MARINER NEWS

BAYTRONICS
CORPORATION

SUBJECT: Mariner 1500 Instruction and Service Manual
Chassis Wiring Diagram, Fig. 15

DATE: September 15, 1976

Fig. 15

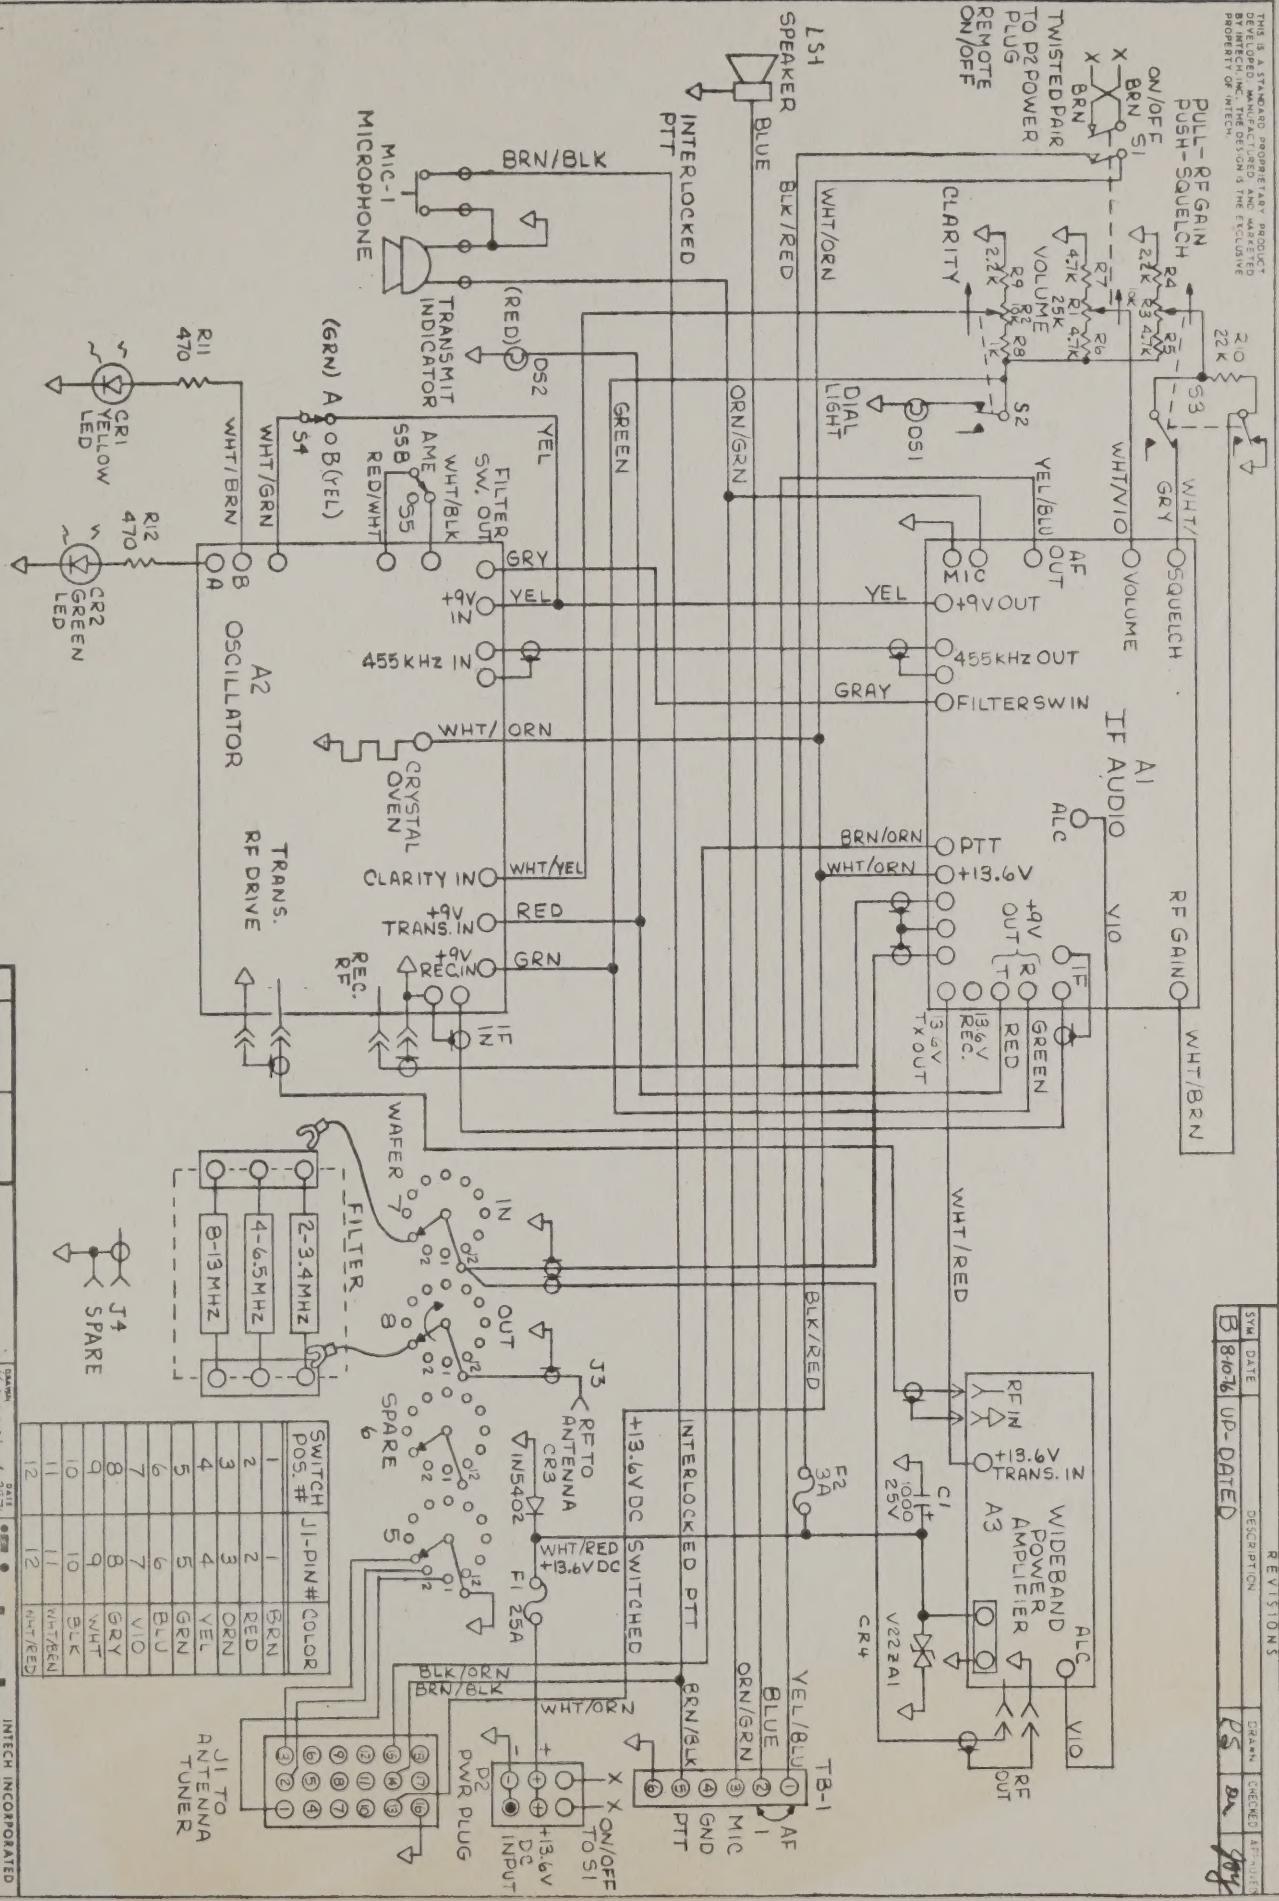
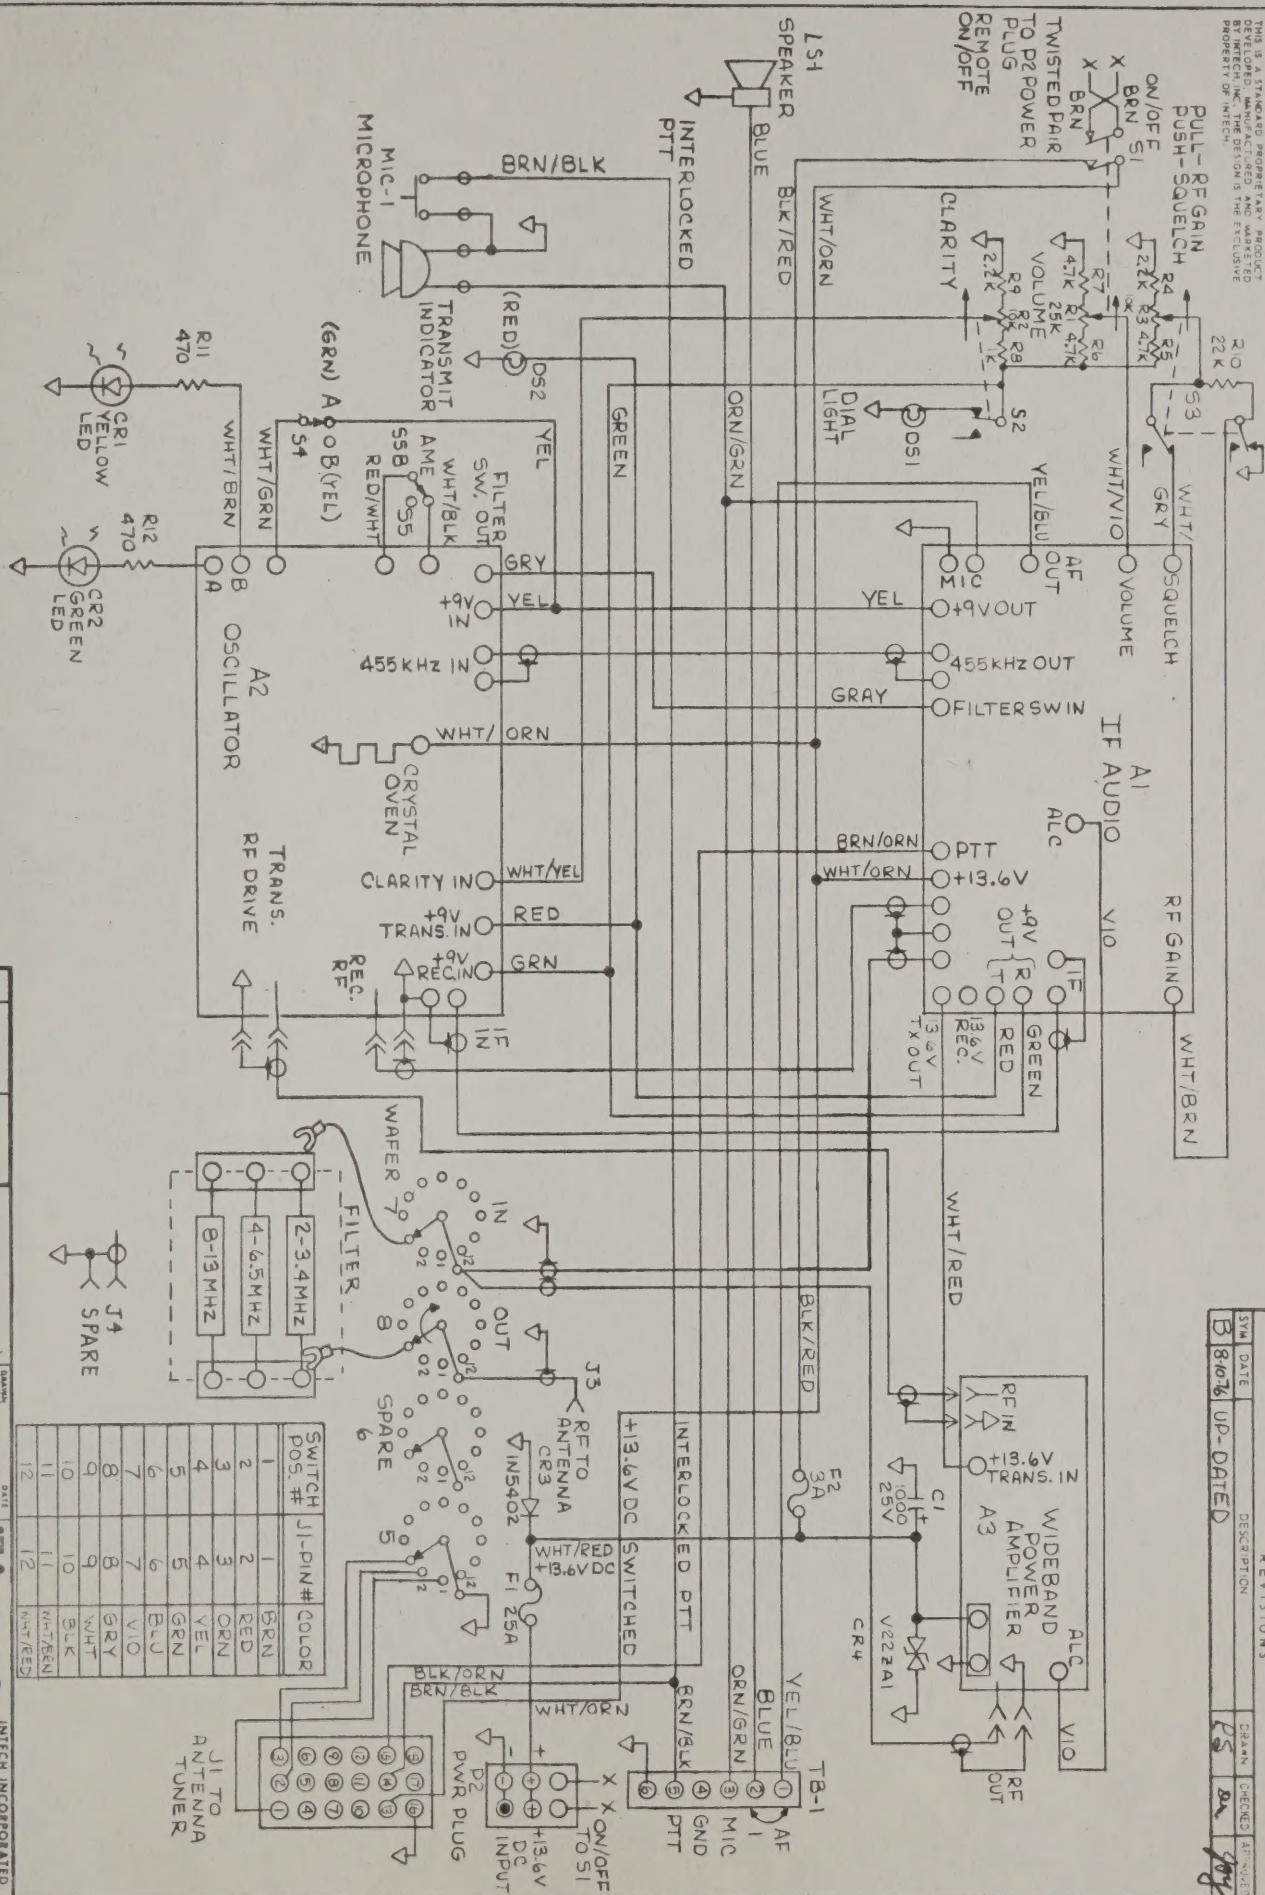
The chassis wiring diagram (5-157041) represents graphically how wires and coaxial cables are connected to the circuit boards. Inadvertently, we crossed two coaxial cables leading from the low pass filter and Receiver RF (A2 board) to the IF Audio Board (A1). Note that the wiring diagram is error, not the actual wiring in the set. Enclosed are two copies of the corrected, revision B, wiring diagram. Please update service manuals as soon as possible.
